UTAH OIL AND GAS CONSERVATION COMMISSION

WELL NO. CISCO FEDERAL #13 API NO. 43-019-30739

APPLICATION FOR PERMIT TO DRILL, DEEPEN, OR PLUG BACK

NEPA CATEGORICAL EXCLUSION REVIEW

CISCO DRILLING & DEVELOPMENT CO.  
 CISCO WELL #13  
 NE 1/4NW1/4 Sec.7, T.20S., R.22 E.  
 SALT LAKE MERIDIAN

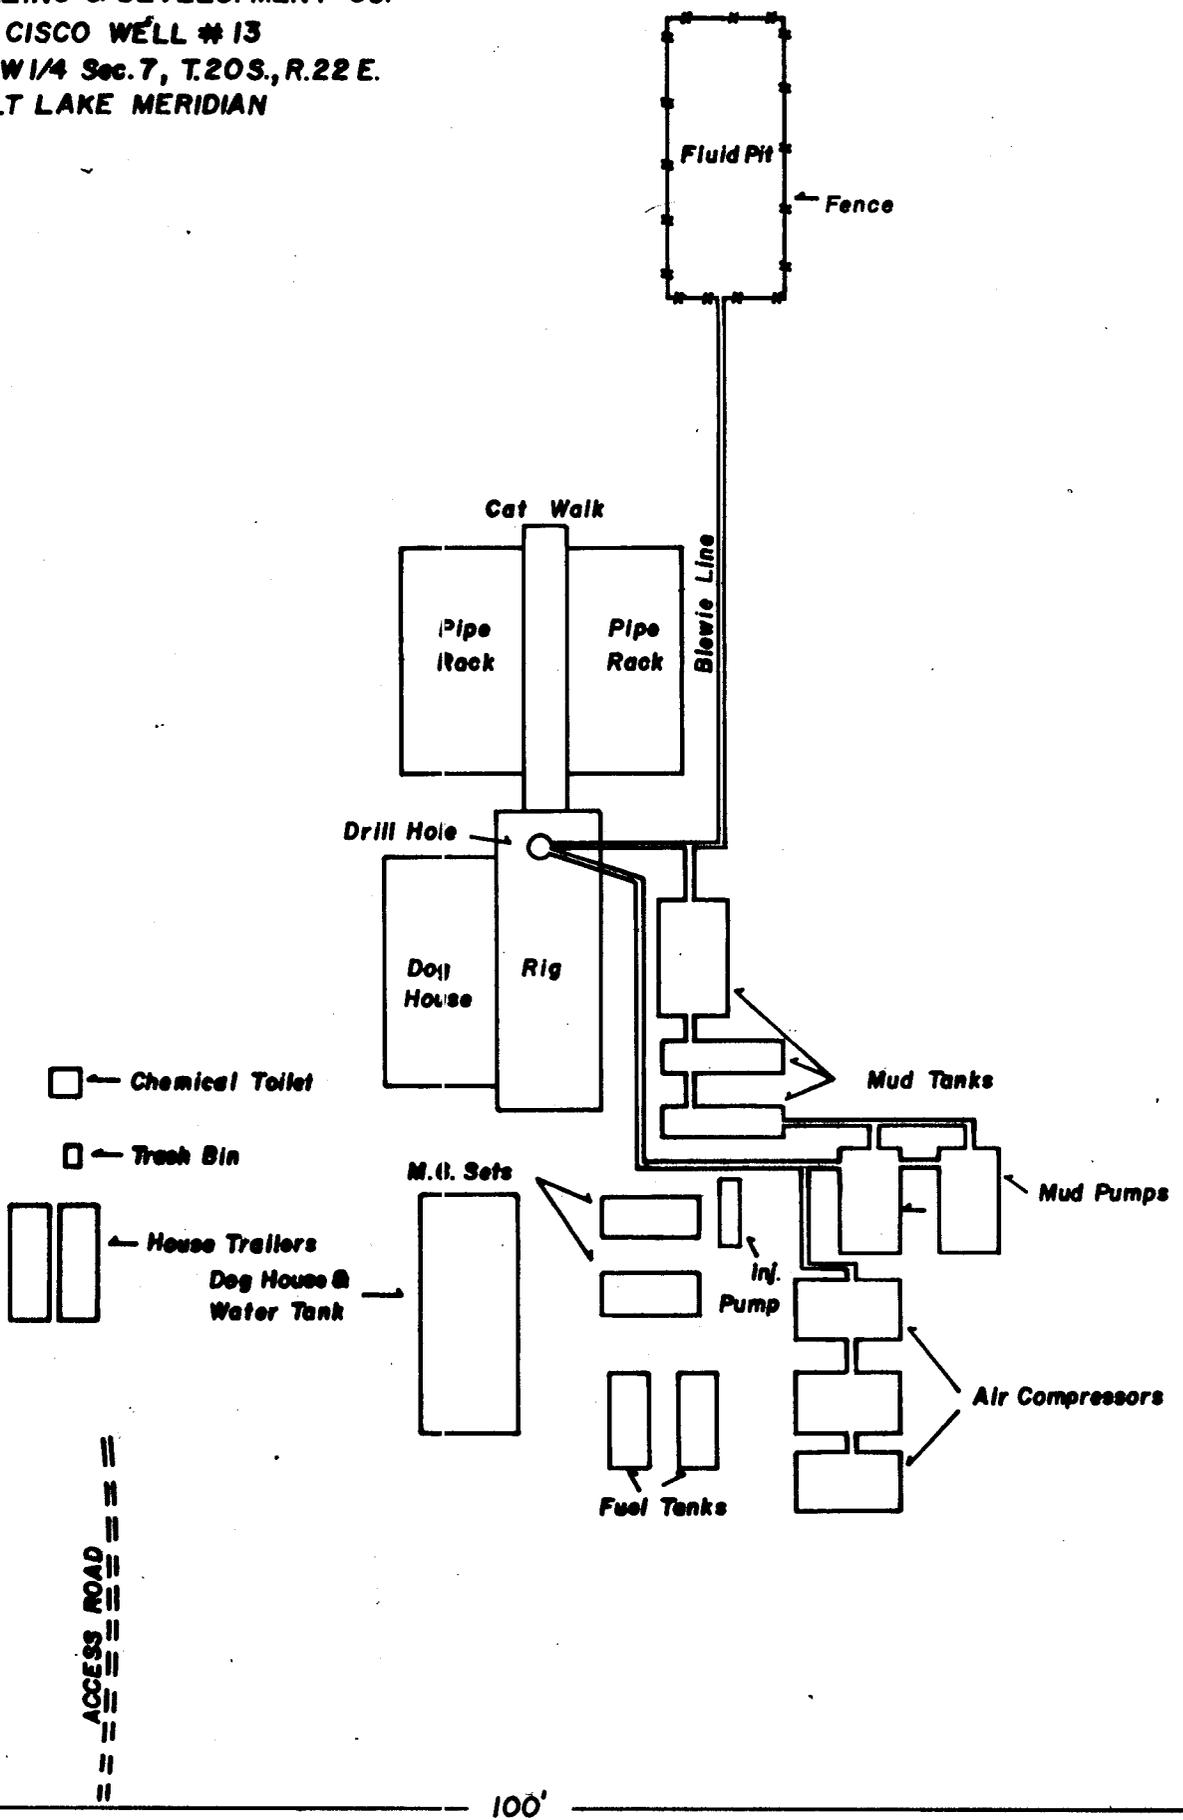
- 1) Reroute the access to the north, maintaining at least a 75' buffer zone between it (the access) and the blooie pit.
- 2) All available topsoil will be stockpiled on the northeast corner of the wellpad.
- 3) Fence the reserve pit on three sides prior to drilling and on the fourth side once the rig moves off.

- 3) The access road will have proper low water crossings installed. Where the access road enters onto the location, this portion has been re-located to come over the North end of the pad and enter from the Northeast corner.

- 4) Because of the road change, the topsoil pile has been relocated to the Northeast side of the location.
- 5) Producer:
  - A) The access road will be upgraded to permanent road specification so to facilitate tank truck traffic.

**PLAN FOR PRODUCTION EQUIPMENT**  
**CISCO DRILLING & DEVELOPMENT CO.**  
**CISCO WELL # 13**  
**NE 1/4 NW 1/4 Sec. 7, T.20S., R.22 E.**  
**SALT LAKE MERIDIAN**

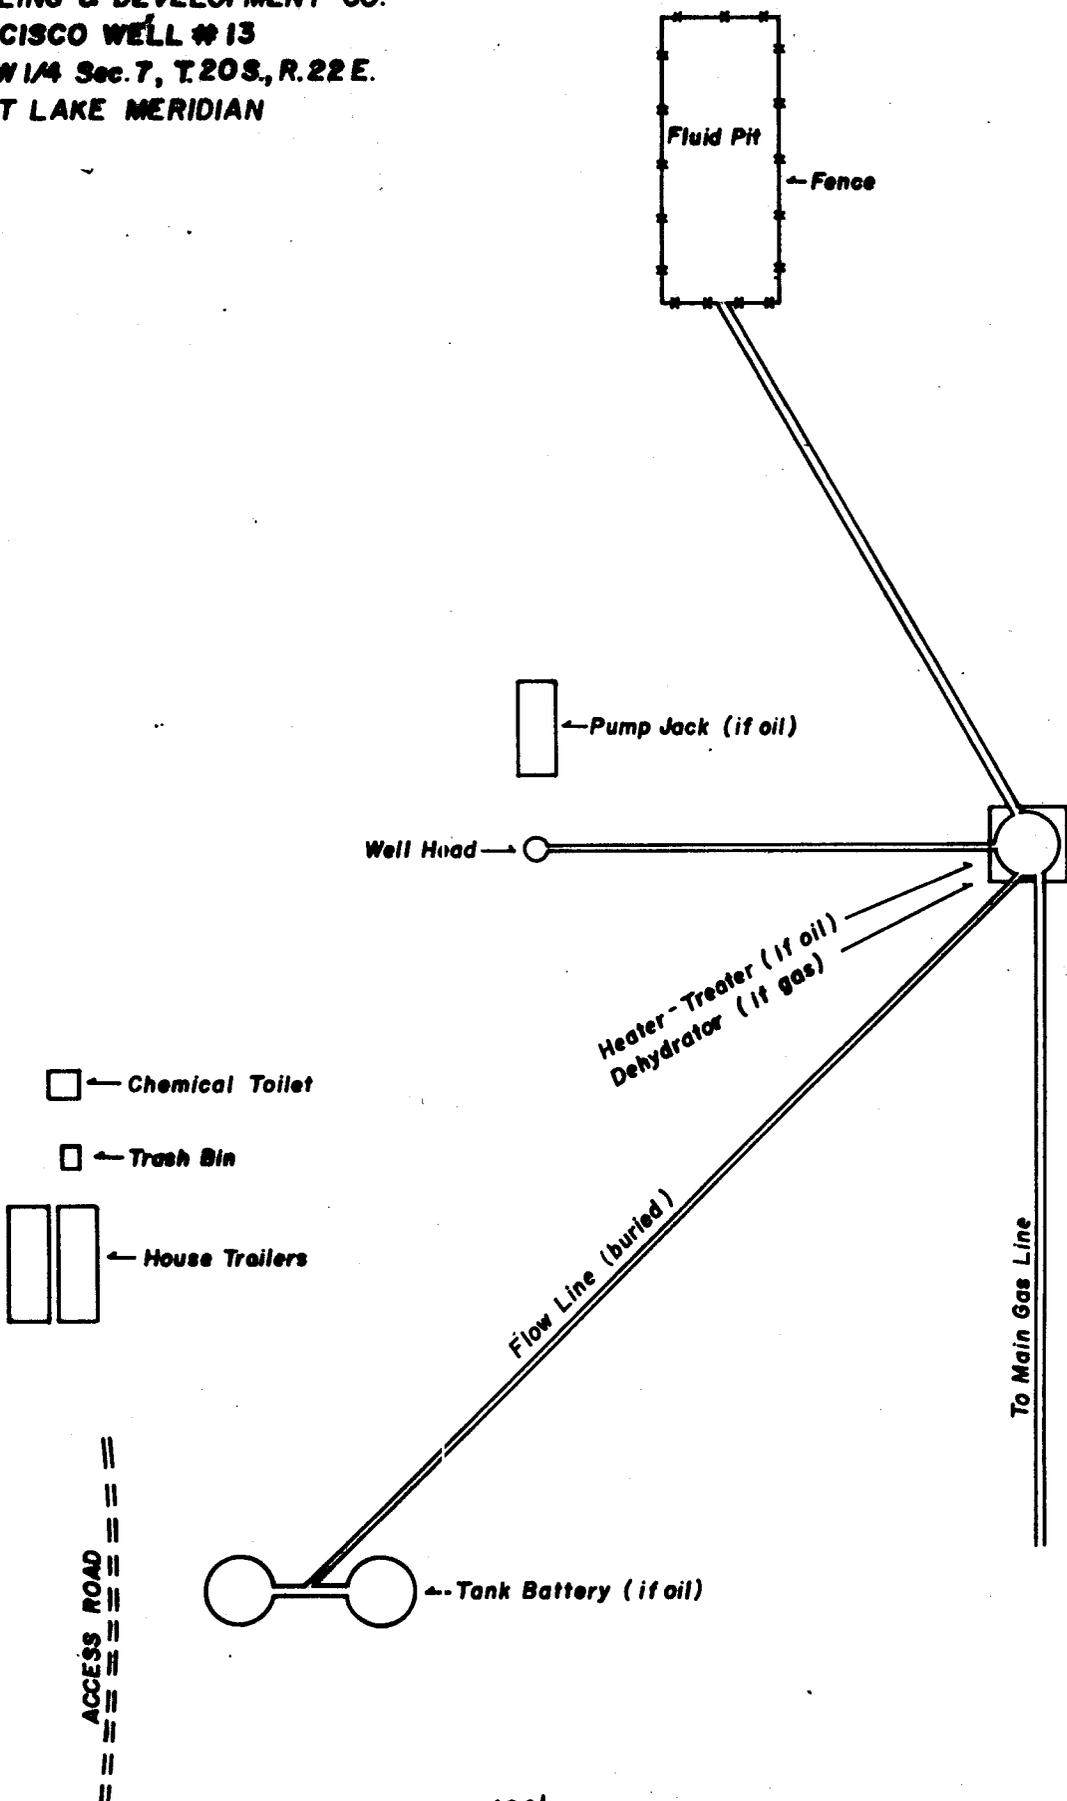
Production Facilities and Flowline NOT Approved

- B) Production facilities are not approved at this time.
  - C) Colors for the production facilities have been enclosed in this permit.
  - D) That portion of the topsoil not used in restoration will be seeded with the grasses from the seed mixture.
